Louisiana Energy Services, LLC
National Enrichment Facility
NRC Docket No. 70-3103

Subject: Response to NRC Review of the 10 CFR 70.72 Summary of Changes for Louisiana Energy Services

- CC-EG-2006-0033**, *Security System UPS and Diesel Generator*
- CC-EG-2007-0061**, *Removal of Diesel Backup Power for Product Pumps and Blending System Trace Heating in SBM-1001*
- CC-EG-2007-0056**, *Process Service Corridor – Addition of Security Access Door*
- CC-EG-2007-0085**, *Modification to Facility Water Feed – From Eunice, NM*
- CC-EG-2006-0073**, *HVAC Design Changes for Centrifuge Assembly Building*
- CC-EG-2007-0226**, *QA Level 2 Definition and QA Level 1 Clarification*
- CC-EG-2007-0189**, *Changes to IROFS Temperature Sensor*
- CC-EG-2007-0232**, *Review of NTS Calc M-0006-02 Water Balance (NTS-LES-0549)*

Figure 3.5-12 Flow Diagram CAB Centrifuge Component Storage Area HVAC System

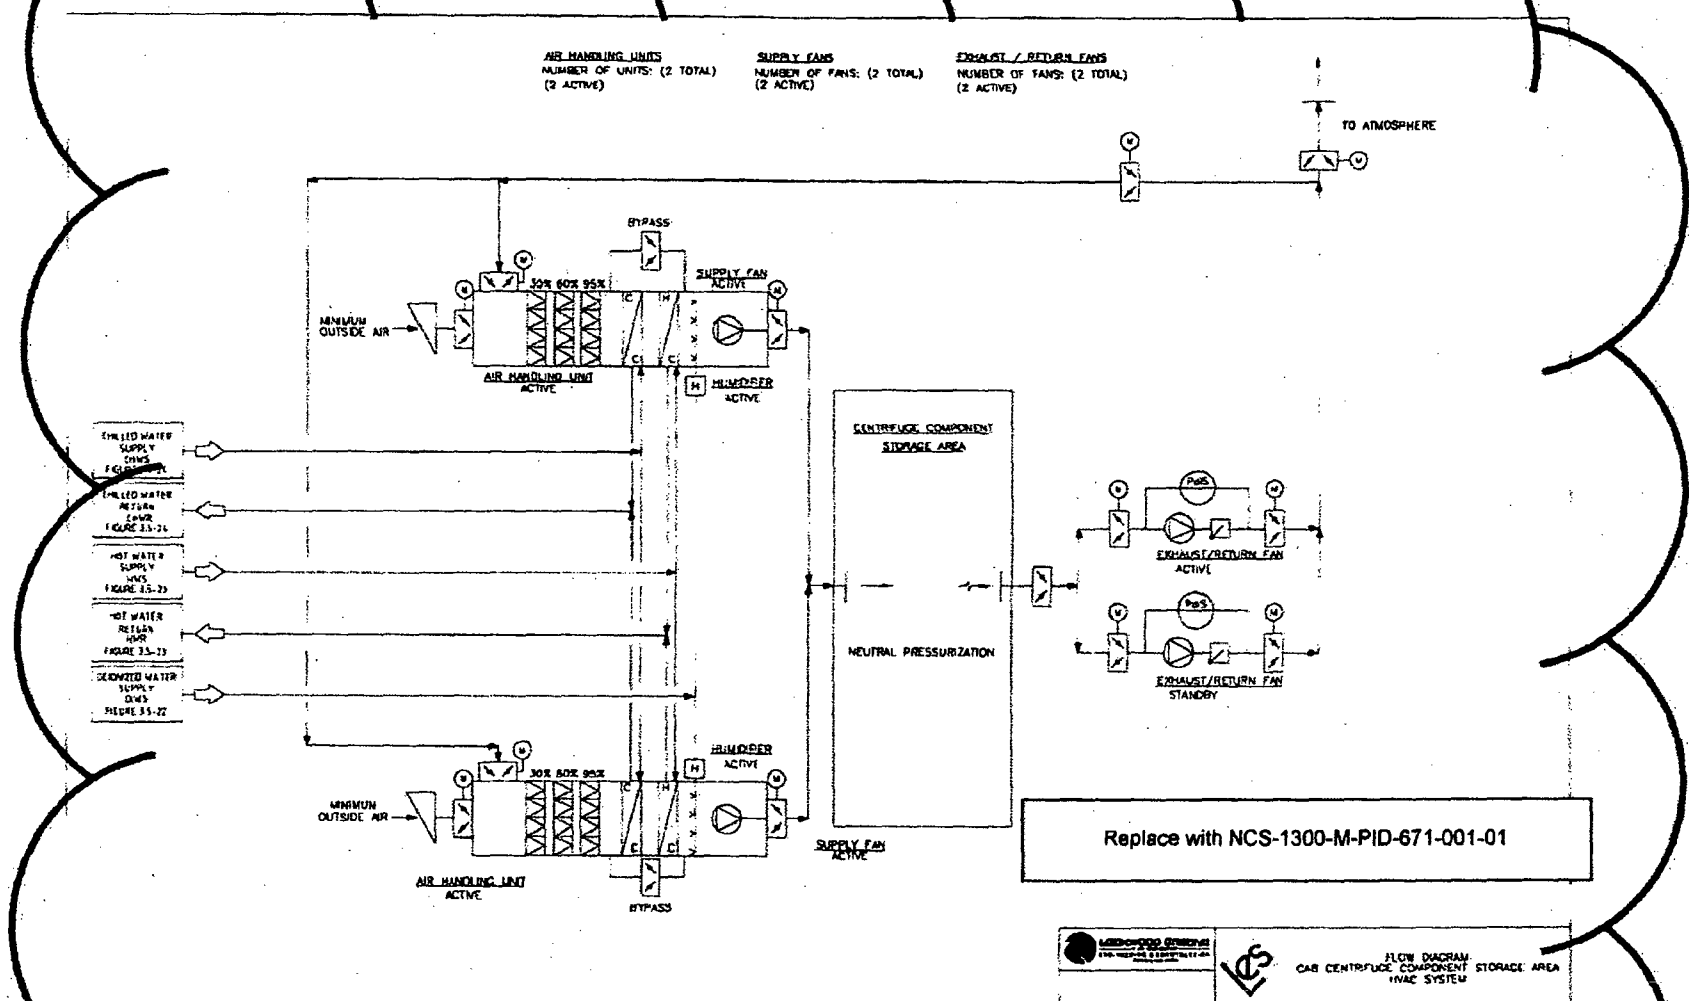
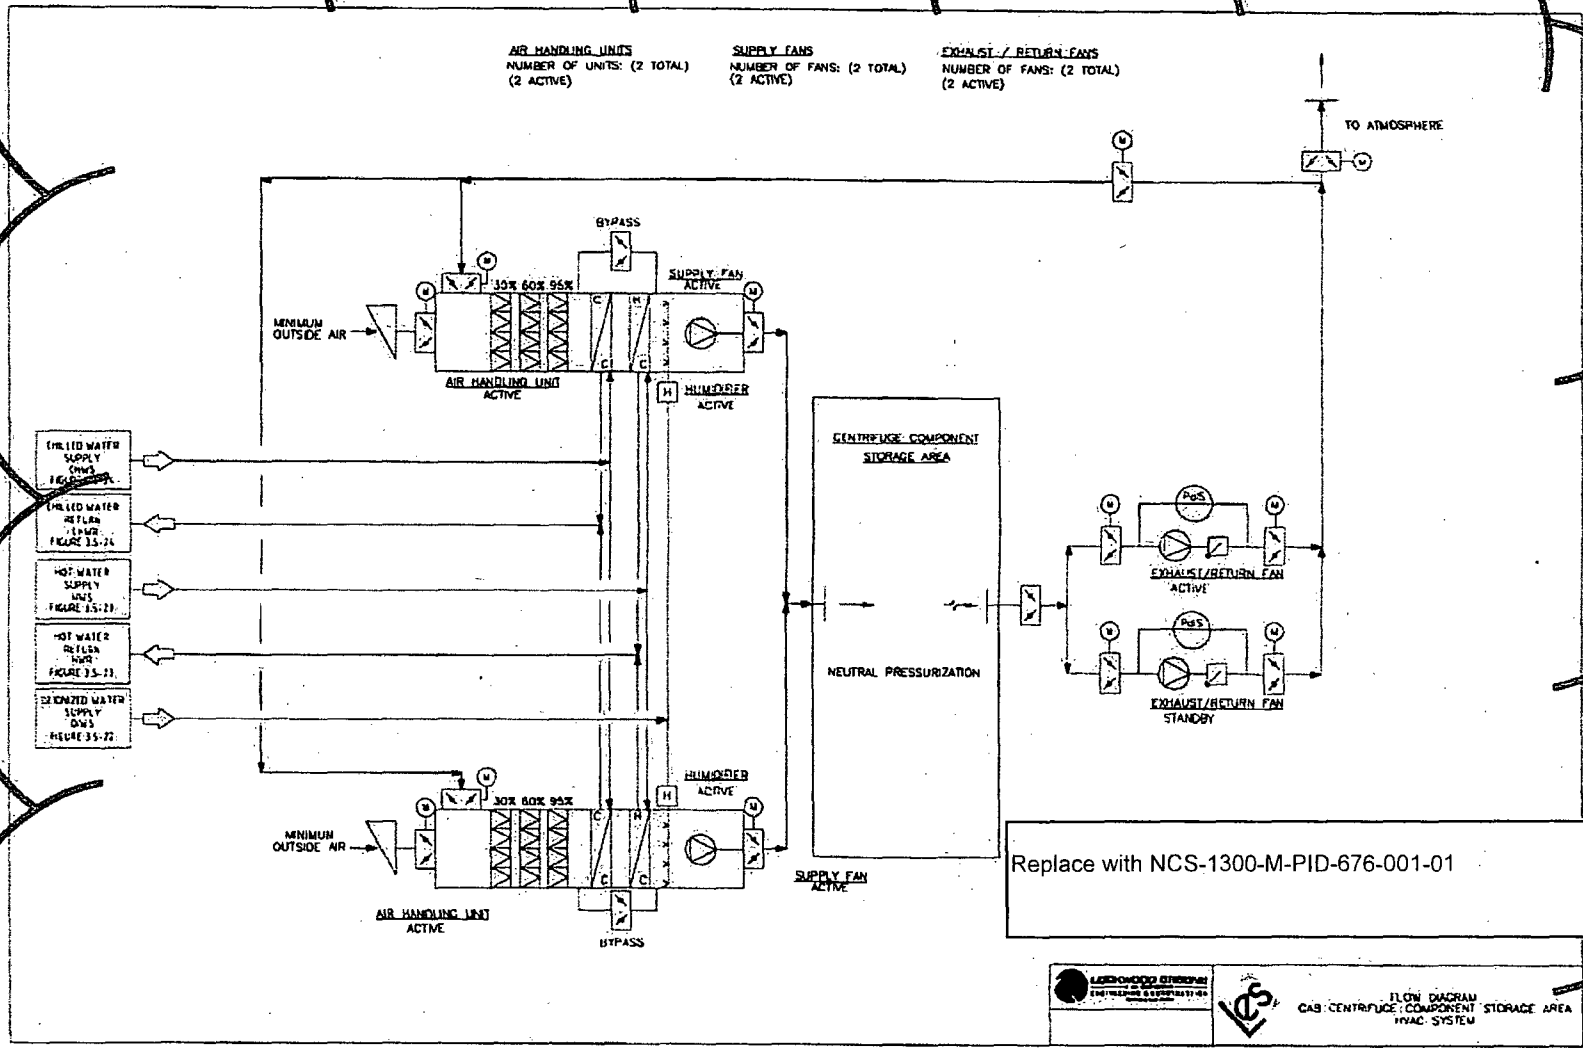
- ISAS Figure 3.5-12, Flow Diagram CAB Centrifuge Component Storage Area HVAC System.
- ISAS Figure 3.5-13, Flow Diagram CAB Centrifuge Storage and Miscellaneous Areas HVAC System.
- ISAS Figure 3.5-14, Flow Diagram CAB Offices and Miscellaneous Rooms HVAC System.
- ISAS Figure 3.5-15, Flow Diagram CAB Centrifuge Assembly Area HVAC System.
- ISAS Figure 3.5-23, Process Flow Diagram Boilers and Hot Water Distribution System.

1. The ventilation systems for the CAB are changing from cooling/heating water exchangers to DX units that utilize refrigerant. Also due to different heat/cooling requirements design flows will be changing. Humidity requirements have changed and a basis needs to be documented for the humidity in the various areas of the CAB. ISA figures 3.4-19, 3.5-12, 3.5-13, 3.5-14, 3.5-15, & 3.5-23 (this figure will be changed by boiler removal CC-EG-2007-0075) will be required to be changed to depict the new configurations and design basis flow requirements.

Figure 3.5-15 Flow Diagram CAB Centrifuge Assembly Area HVAC System

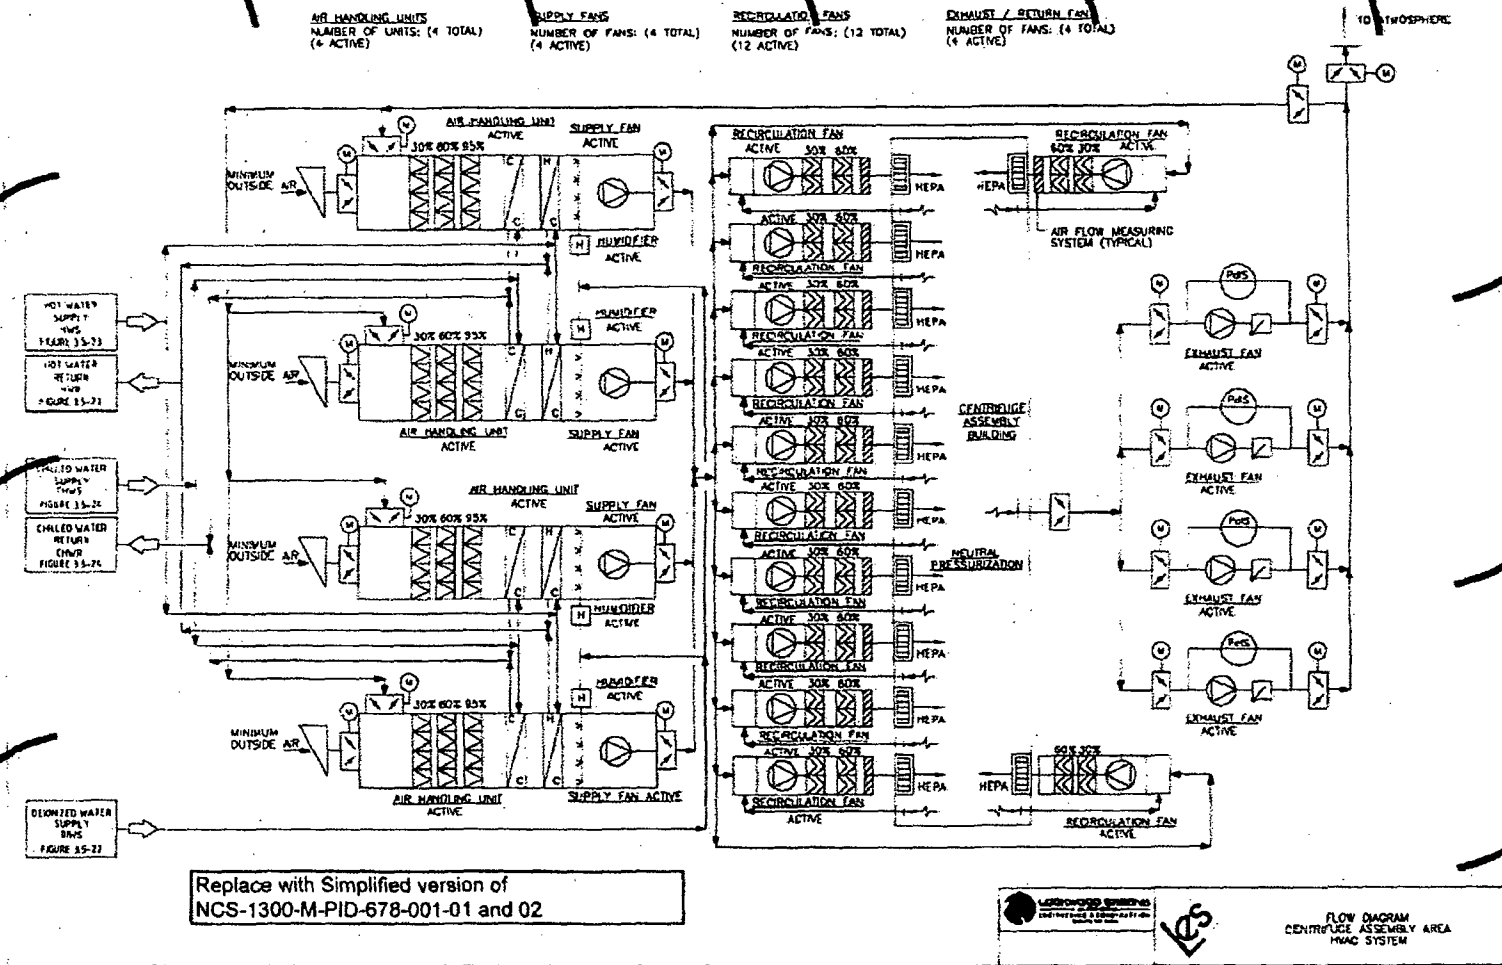
Assigned CRE: E. Dale Pruitt <i>E. Dale Pruitt</i> 9/12/07 Due Date NA		
Evaluation Results (Level 1-4): Creating actions for Tracking Item CR.		
Safety Significance (Level 1): N/A		
Extent of Condition (Level 1): N/A		
Generic Implications (Level 1): N/A		
Corrective Actions (including preventive actions for Level 1)	Assigned to:	Due Date
<u>Action Item 1</u> Provide engineering basis documentation to support humidity control and air flow basis for the new design for the CAB DX units. Also provide updated figures with the new configurations for the new DX units for the following: ISA Figure 3.4-19, Process Flow Diagram Centrifuge Test & d Post Mortem Facilities Exhaust Filtration System. ISA Figure 3.5-12, Flow Diagram CAB Centrifuge Component Storage Area HVAC System. ISA Figure 3.5-13, Flow Diagram CAB Centrifuge Storage and Miscellaneous Areas HVAC System. ISA Figure 3.5-14, Flow Diagram CAB Offices and Miscellaneous Rooms HVAC System. ISA Figure 3.5-15, Flow Diagram CAB Centrifuge Assembly Area HVAC System.	Design Management Dale Pruitt	11/15/09

Figure 3.4-19 Process Flow Diagram Centrifuge Test and Post Mortem Facilities Exhaust Filtration System

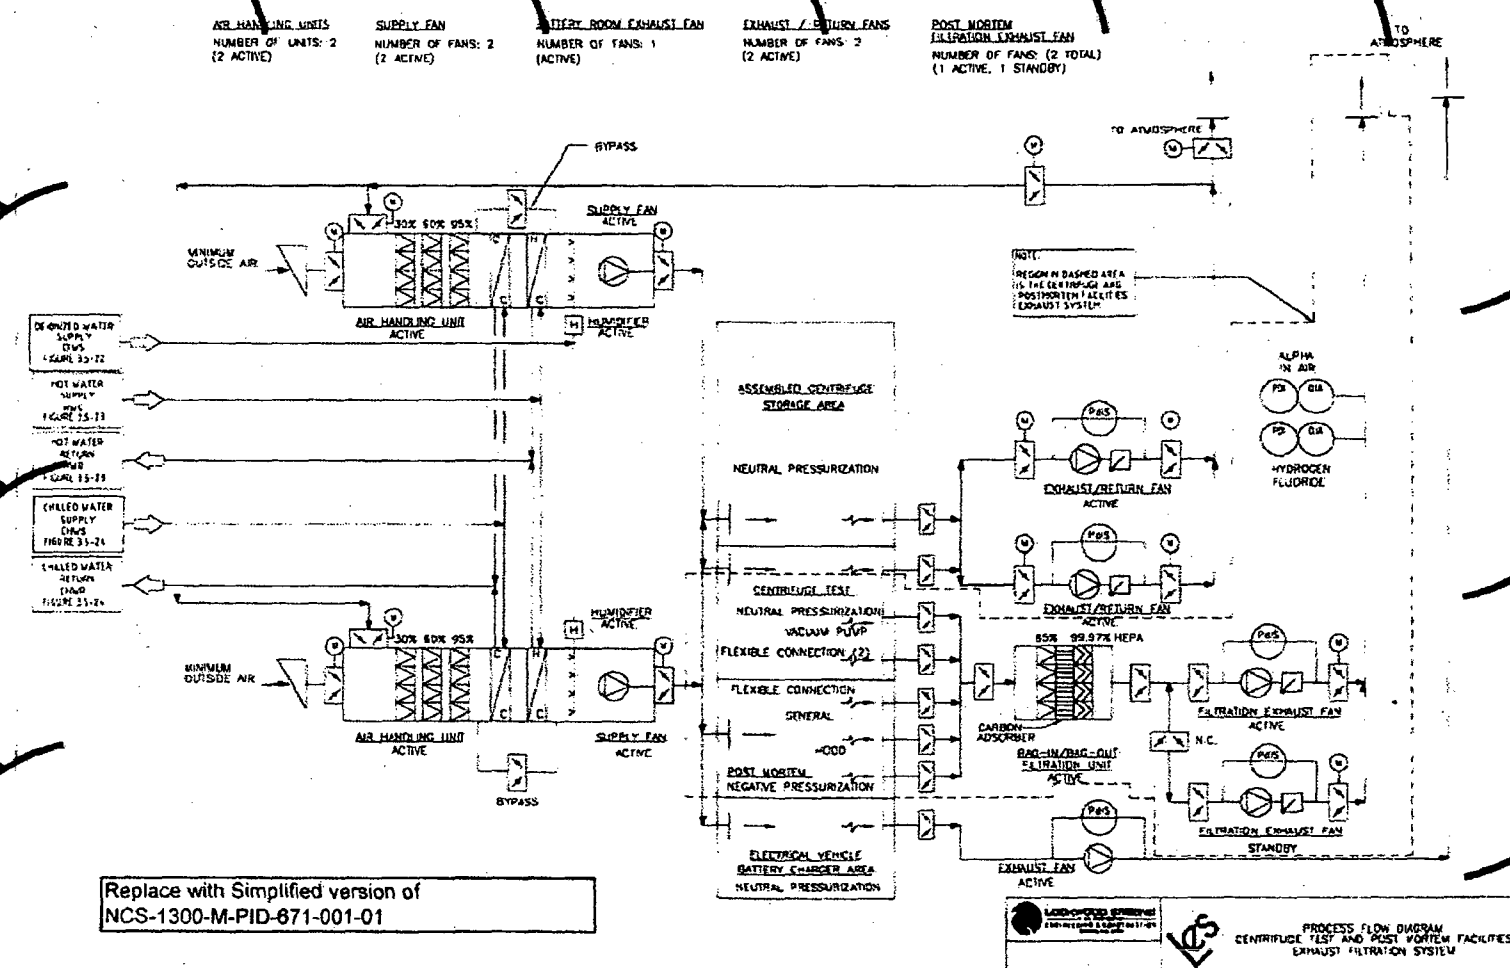
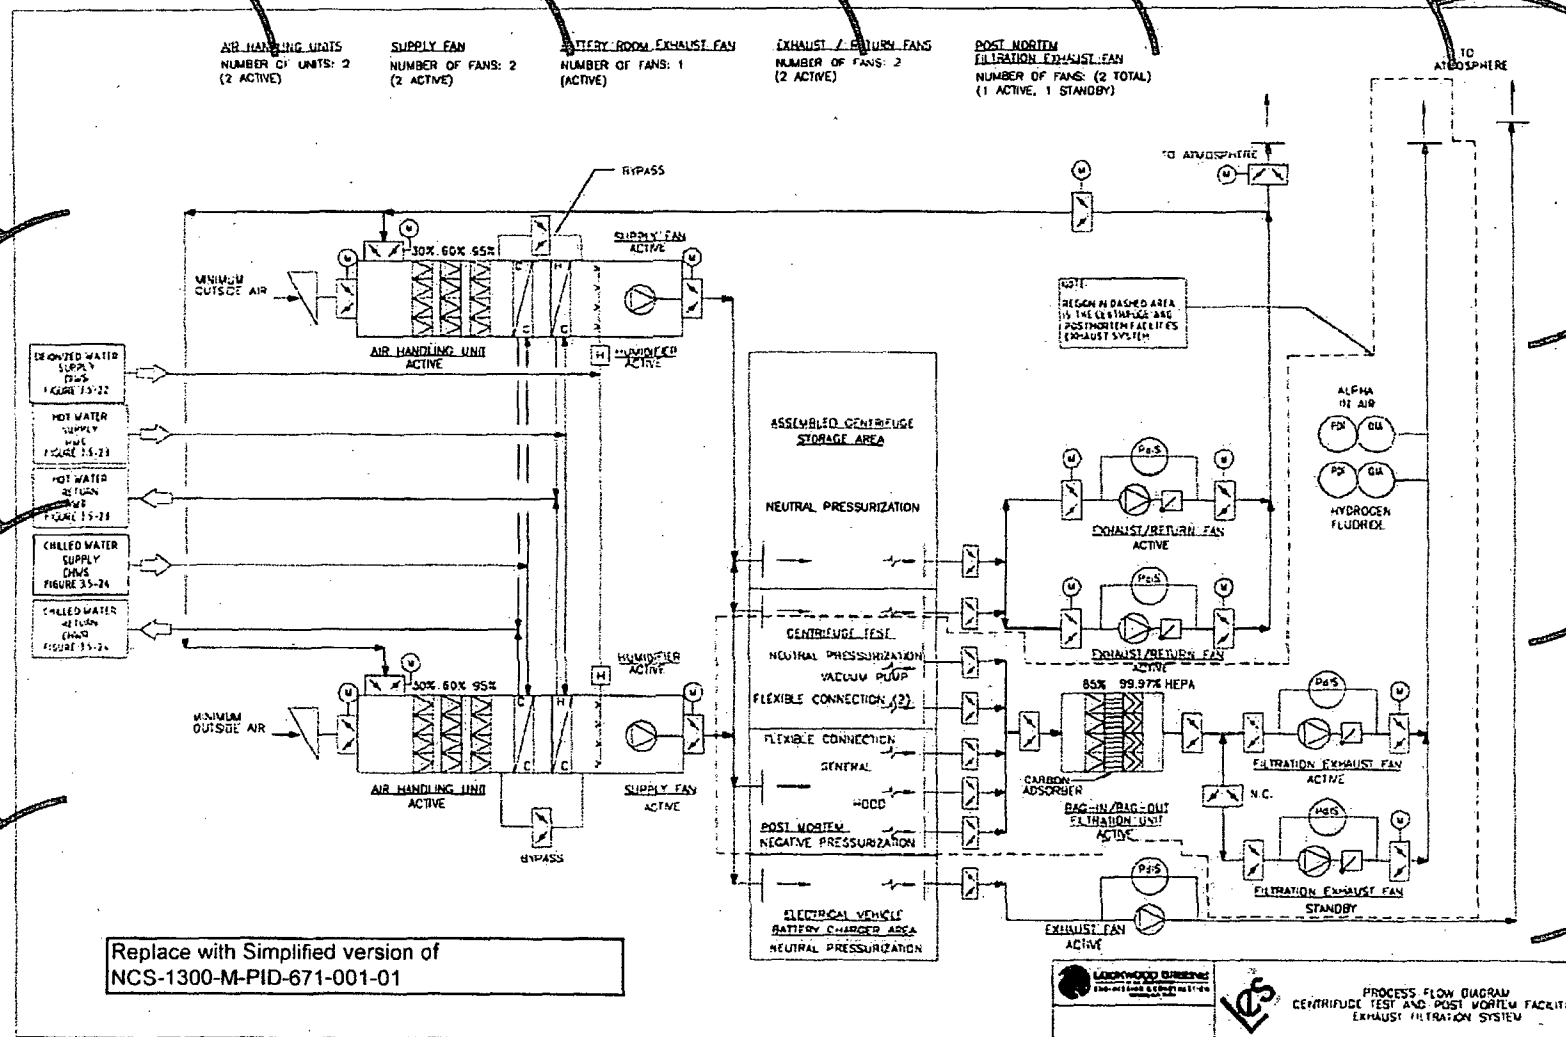
- ISA Figure 3.5-12, Flow Diagram CAB Centrifuge Component Storage Area HVAC System.
- ISA Figure 3.5-13, Flow Diagram CAB Centrifuge Storage and Miscellaneous Areas HVAC System.
- ISA Figure 3.5-14, Flow Diagram CAB Offices and Miscellaneous Rooms HVAC System.
- ISA Figure 3.5-15, Flow Diagram CAB Centrifuge Assembly Area HVAC System.
- ISA Figure 3.5-23, Process Flow Diagram Boilers and Hot Water Distribution System.
- ISAS Figure 3.4-19, Process Flow Diagram Centrifuge Test and Post Mortem Facilities Exhaust Filtration System
